Park Redevelopment, Woodquay,
Galway City

Quality Audit

Stage 1 & 2 Road Safety Audit

Document Ref:	P24110-PMCE-XX-XX-RP-SA-5_0001
----------------------	---------------------------------------

2.4 Layout of Vehicular Access Driveway

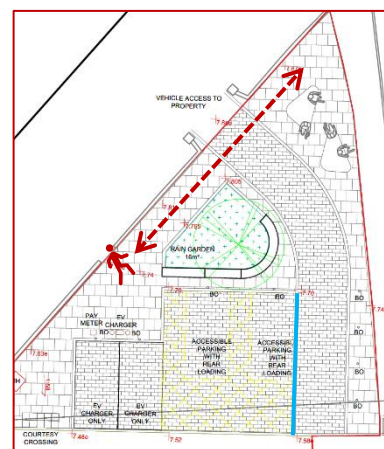
A new access lane has been indicated at the southeastern corner of the scheme to facilitate vehicular access to an existing property at this location. It is, however, unclear if there would be a level difference between the lane and the footpath which bounds it on both sides. Should there be a level difference between these two surfaces, the absence of a pedestrian crossing along the likely pedestrian desire line, adjacent the property boundary line, may lead to mobility and visually-impaired pedestrians experiencing difficulties navigating the road layout.

In addition, should there be a level difference, it is unclear if this kerb would extend across the southern side of the mobility-impaired parking space at this location. Should a kerb be provided across the southern side of the mobility-impaired parking space, this may result in the parking space being of an insufficient size and vehicle occupants may, therefore, experience difficulties entering/exiting their vehicle from this side.

Alternatively, should there be no level difference between the lane and the surrounding footpath, this may lead to visually-impaired pedestrians inadvertently entering the lane.

Should there be a level difference between the vehicular access lane and its surrounding footpath, a pedestrian crossing including tactile paving should be provided across the access and a flush kerb provided along the southern side of the mobility-impaired parking space.

Should there be no level difference, suitable measures should be provided to guide visually-impaired pedestrians through this area.

3.2 Bin within Footpath

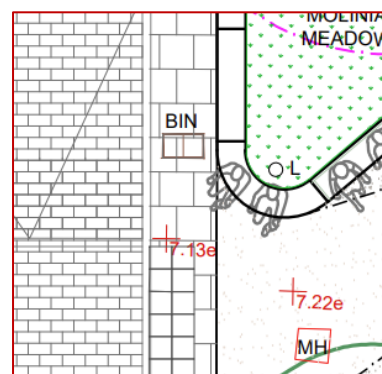
A bin has been indicated in a central position within the proposed footpath at the northern boundary of Woodquay Park immediately to the east of the raised table pedestrian crossing. The bin may obstruct the path of pedestrians travelling within the footpath.

Relocate the bin to a location where it will not obstruct pedestrian movement.

3.3 Pedestrian Desire Line Not Catered For

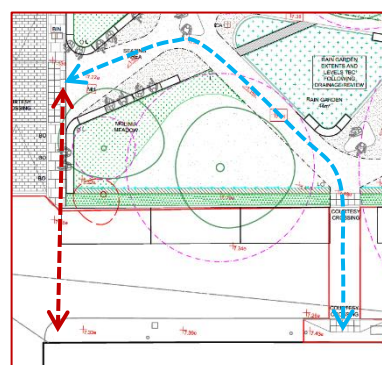
A new footpath is indicated at the northern boundary of Woodquay Park. No pedestrian crossings have been indicated at either end of the footpath to provide a connection across Corrib Terrace or Riverside, however, this would be the most direct route for pedestrians between these roads, particularly those who wish to travel south on Corrib Terrace. This may, therefore, lead to pedestrians choosing to cross Corrib Terrace or Riverside at the end of the proposed footpath, away from the proposed pedestrian crossing and where full height kerbs would likely be located. Full height kerbs along pedestrian desire lines may increase the risk of trips and falls and present barriers for elderly and mobility impaired pedestrians.

The pedestrian routes to the east and west at the park's northern end should be made unattractive to deter their use and thus pedestrians crossing Corrib Terrace or Riverside at these locations. This may be achieved by extending the grassed verges at either end of the footpath northwards across the proposed footpaths, or by an alternative appropriate measure.

3.4 Informal Parking at Pedestrian Crossing

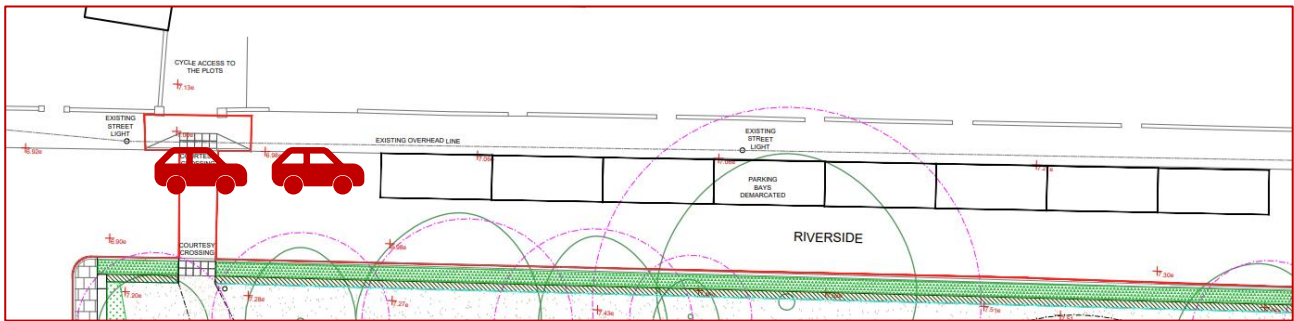
A new uncontrolled pedestrian crossing has been indicated on Riverside at the northeastern corner of the park, which would link a cycle access to 'The Plots' and the proposed Woodquay Park. There are a number of on-street parking bays located along the northeastern side of Riverside, which would be demarcated. No measures, however, have been indicated at the access to 'The Plots' to prohibit informal parking at this location, outside the demarcated parking spaces. Should these formal parking spaces be occupied, drivers may park adjacent to the access where they may encroach into, or block, the crossing. If a driver were to park at this location, this would obstruct pedestrian and cyclist movement across Riverside between the park and 'The Plots.'

Measures (e.g. double yellow lines) should be provided at this location to prohibit informal parking.

3.1.1 Inter-Visibility Restricted by Parking Spaces

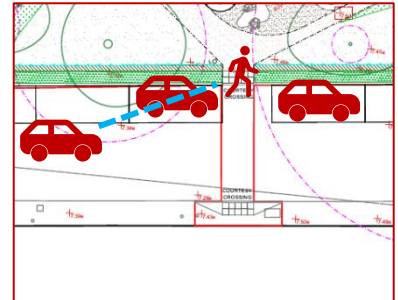
Summary: Inter-visibility between drivers and pedestrians crossing Corrib Terrace from Woodquay Park may be restricted by parked cars on both sides of the crossing.

An uncontrolled pedestrian crossing has been indicated on Corrib Terrace. The pedestrian crossing point exiting Woodquay Park would, however, be located between two parking spaces.

Should one, or both, of these parking spaces be occupied, this may lead to the inter-visibility between approaching drivers and pedestrians waiting at the eastern side of the crossing being restricted. This may lead to a pedestrian entering the carriageway when a driver may not anticipate them to do so resulting in a subsequent risk of vehicle-pedestrian collisions.

The parking spaces should be removed or relocated such that sufficient inter-visibility between a driver, approaching from either direction, and a pedestrian exiting the park at the crossing is provided at this location.

3.1.1	Y	N	Location of crossing point has been moved east to improve visibility. A build-out has been incorporated to improve inter-visibility between drivers and pedestrians	Yes

3.1.2 Inter-visibility Restricted by Hedge Line

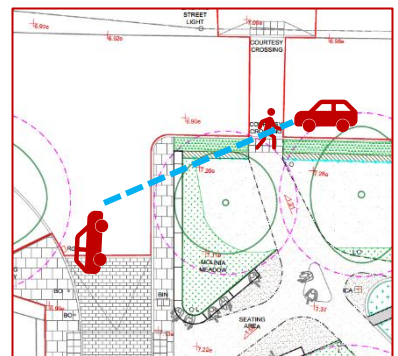
Summary: Inter-visibility between drivers and all road users at the northeastern corner of Woodquay Park may be restricted by hedge planting/fencing.

A row of hedge planting, which would initially be supported by a timber post and rail fence, has been indicated around the border of Woodquay Park. A new uncontrolled pedestrian crossing has also been indicated on Riverside at the northeastern corner of the park.

Information in relation to the intended height of the hedgerow has not been provided and, should it grow too high, this may lead to inter-visibility between drivers approaching this corner from each direction, or southbound drivers and pedestrians waiting at the western side of the crossing being restricted.

This may lead to a southbound driver cutting the corner ahead of an opposing driver turning onto Riverside resulting in a subsequent risk of low-speed head-on collisions, or to a pedestrian entering the carriageway when a driver may not anticipate them to do so and a subsequent risk of vehicle-pedestrian collisions.

The hedgerow planting should be routinely maintained and cut to a height which provides sufficient inter-visibility between all road users at this location.

3.1.2	Y	N	Hedge planting has been removed from this location	Yes
3.1.3	Y	Y	LUC Hard Landscape drawings 12357-LUC-XX-00-DR-L-0106 and 12357-LUC-XX-00-DR-L-0107 provide full details of kerbs

3.1.3 Kerb Heights

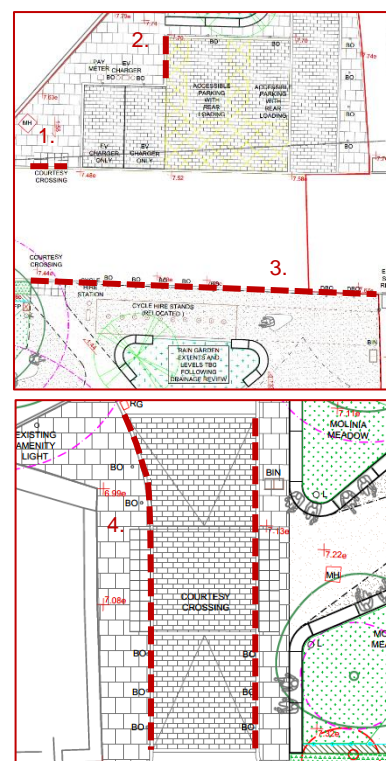
Summary: It is unclear if kerbs of an appropriate height would be provided at all locations within the scheme.

The proposed kerbs within the scheme have been indicated as having a varying height within the legend on the drawing provided and it is, therefore, unclear whether kerbs of an appropriate height would be provided at all locations, including the following:

1. All pedestrian crossings where the provision of kerbs with an upstand greater than 6mm may present trip hazards to pedestrians, or barriers to mobility impaired pedestrians, particularly wheelchair users.

2. Adjacent the mobility-impaired parking spaces at the southeastern corner of the scheme where the absence of a dropped kerb with an appropriate upstand could lead to mobility-impaired vehicle occupants experiencing difficulties entering/exiting their vehicle.

3. At the eastern and western boundary of Woodquay Park at its southern end, where the absence of full height kerbs, outside of pedestrian crossing points, may lead to visually-impaired pedestrians inadvertently entering the carriageway where there is a risk of being struck by a vehicle.

4. At the raised table, indicated at the northern boundary of Woodquay Park, where the provision of flush kerbs outside of the pedestrian crossing may lead to visually-impaired pedestrians inadvertently entering the carriageway where there is a risk of being struck by a vehicle.

Kerbs of a suitable height, appropriate for their location and use, should be provided throughout the scheme.

3.1.4 Layout of Vehicular Access Driveway

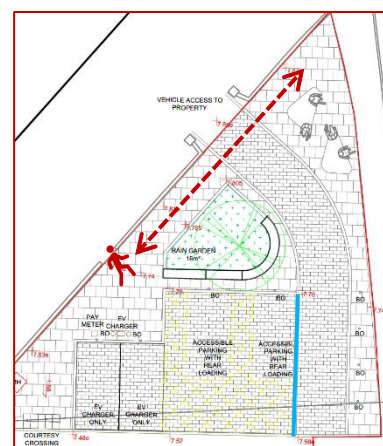
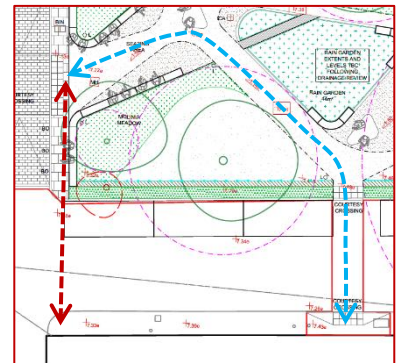
Summary: The layout of the proposed vehicular lane providing access to an existing property is unclear and may result in mobility and visually-impaired pedestrians experiencing difficulties navigating the road layout at this location.

A new access lane has been indicated at the southeastern corner of the scheme to facilitate vehicular access to an existing property at this location. It is, however, unclear if there would be a level difference between the lane and the footpath which bounds it on both sides. Should there be a level difference between these two surfaces, the absence of a pedestrian crossing along the likely pedestrian desire line, adjacent the property boundary line, may lead to mobility and visually-impaired pedestrians experiencing difficulties navigating the road layout.

In addition, should there be a level difference, it is unclear if this kerb would extend across the southern side of the mobility-impaired parking space at this location. Should a kerb be provided across the southern side of the mobility-impaired parking space, this may result in the parking space being of an insufficient size and vehicle occupants may experience difficulties entering/exiting their vehicle from this side.

Alternatively, should there be no level difference between the lane and the surrounding footpath, this may lead to visually-impaired pedestrians inadvertently entering the lane where there is a risk of being struck by a vehicle.

Should there be a level difference between the vehicular access lane and its surrounding footpath, a pedestrian crossing including tactile paving should be provided across the access and a flush kerb provided along the southern side of the mobility-impaired parking space.

Should there be no level difference, suitable measures should be provided to guide visually-impaired pedestrians through this area.

3.1.4	Y	Y	There is no level difference between surfaces. Hazard warning paving has been introduced at location indicated to raise awareness to visually-impaired

3.1.6 Width of Internal Paths

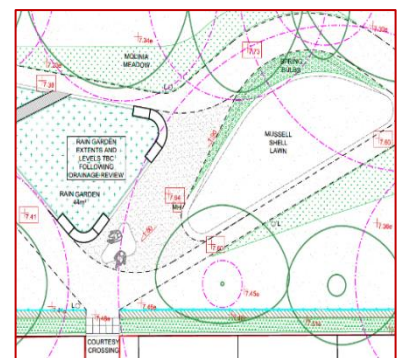
Summary: The width of the paths within Woodquay Park may not be sufficient to accommodate its intended users.

A new path network is proposed within Woodquay Park. No information in relation to the width of the paths has been provided, however, sections of the path have been measured as being approximately 1m wide. This width may lead to mobility-impaired pedestrians, particularly wheelchair users, experiencing difficulties when travelling through the park.

In addition, it is unclear if it is intended for the paths to be used by both pedestrians and cyclists. Should the path network be shared by pedestrians and cyclists, narrow paths may result in an increased risk of conflicts between these road users.

If the paths within Woodquay Park are intended to be shared surfaces, they should be a minimum of 2.5m wide. If these are intended to be used only by pedestrians, they should be a minimum of 1.2m wide, but preferably 1.8m wide.

3.1.5	Y	Y	Planting has been extended across to block the ends of the routes	
3.1.6	Y	Y	Paths are only intended to be used by pedestrians. All paths widened to 1.2m minimum. Main paths are 2.0m wide.

3.1.8 Visibility of Bollards

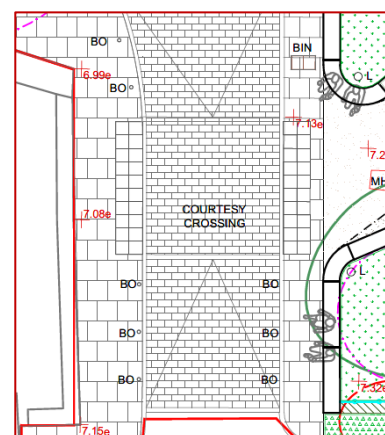
Summary: It is unclear if the proposed bollards would be sufficiently visible during the hours of darkness.

A number of stainless steel bollards have been indicated within the scheme, including on the western side of Riverside and on both sides of the proposed raised table at the park's northwestern boundary. Should the bollards not include reflective measures, there is a risk that they would not be sufficiently visible during the hours of darkness.

In addition, it is unclear if the bollards would be sufficiently setback from the edge of the carriageway.

If the bollards are not sufficiently visible to approaching drivers during the hours of darkness, or should they be located too close to the edge of the carriageway, there is a risk of vehicles striking the bollards and material damage collisions.

3.1.7	Y	Y	Tactile paving at all in-line crossings extended to 1.2m depth	
3.1.8	Y	Y	Bollards have been repositioned 450mm away from edge of carriageway and reflective strips included within specification shown on Hard Landscape plans 12357-LUC-XX-00-DR-L-0106 and 12357-LUC-XX-00-DR-L-0107

3.1.9 Absence of Drainage Measures

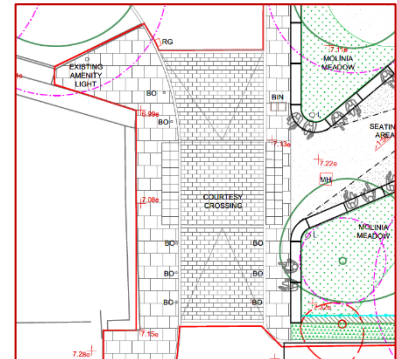
The proposed bollards should include reflective measures, such as a reflective band, and be located a minimum of 450mm from the edge of the carriageway.

Summary: It is unclear if the carriageway would sufficiently shed surface water at the raised table.

A new raised table has been indicated at the northern boundary of Woodquay Park. There appears to be an existing gully at the northeastern corner of the raised table, however no additional drainage measures appear to be proposed at this location. The existing drainage measures may fail to sufficiently shed surface water which may accumulate at the bottom of the raised table. If the carriageway is not sufficiently drained there is a risk of ponding and loss of traction resulting in the potential for loss of control type incidents, particularly during wet and icy weather conditions.

Sufficient drainage measures should be provided at the raised table such that the carriageway on both sides sufficiently sheds surface water.

3.1.11 Location of Motorcycle Parking Spaces

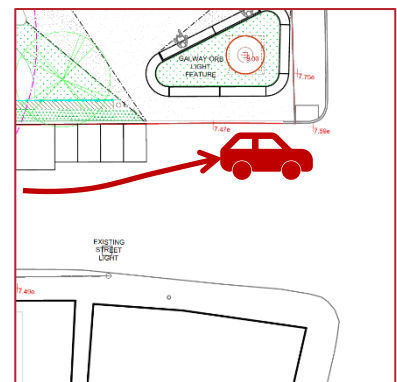
Summary: It is unclear if the swept path of drivers taking up a position at the Stop line on Corrib Terrace would be accommodated due to the location of the motorcycle parking spaces.

A row of motorcycle parking spaces has been indicated on the western side of Corrib Terrace a short distance upstream of its junction with Headford Road. Due to the location of these parking spaces, it is unclear if a driver taking up a position at the Stop line would be able to do so comfortably if these spaces were occupied. Should sufficient space not be available for these drivers, this may result in material damage collisions between vehicles and parked motorcycles.

Confirm, via a swept path analysis, that a driver can safely position themselves at the Stop line when the motorcycle parking spaces are occupied.

To be Completed by Designer				To be Completed by Audit Team Leader
Paragraph No. in Safety Audit Report	Problem Accepted (Yes/No)	Recommended Measure(s) Accepted (Yes/No)	Describe Alternative Measure(s). Give reasons for not accepting recommended measure. Only complete if recommended measure is not accepted	Alternative Measures or Reasons Accepted by Auditors (Yes/No)
3.1.9	Y	Y	Additional gulleys shown on PUNCH drainage drawing 31101-PUNCH-01-XX-DR-C-0101	
3.1.10	Y	Y	No cycle access is proposed within the park.	
3.1.11	Y	Y	Refer to PUNCH swept path drawings 231101-PUNCH-01-XX-DR-C-0601, 0602, 0603. Parking spaces have been adjusted to ensure no clash with swept path of drivers taking up a position at the Stop line

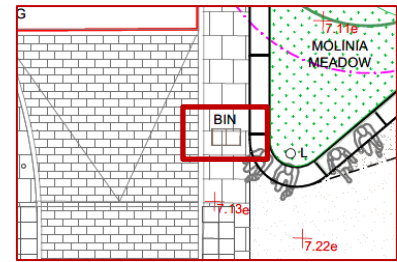
- 4.1 A bin has been indicated in a central position within the proposed footpath at the northern boundary of Woodquay Park immediately to the east of the raised table pedestrian crossing. The bin may obstruct the path of pedestrians travelling within the footpath and it should, therefore, be relocated.

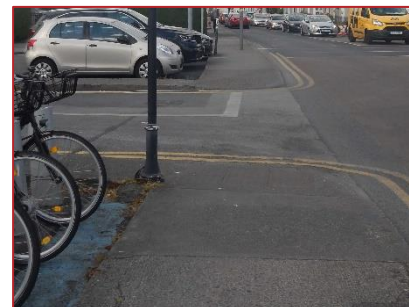
- 4.3 The tactile paving indicated at the in-line pedestrian crossings at Riverside and Corrib Terrace, where pedestrians cross the road in their direction of travel, would be of an insufficient depth for this type of crossing. This may lead to a visually-impaired pedestrian stepping over the tactile paving and inadvertently entering the carriageway where there is an increased risk of being struck by a vehicle. Tactile paving at all in-line pedestrian crossings should be a minimum of 1.2m in depth.
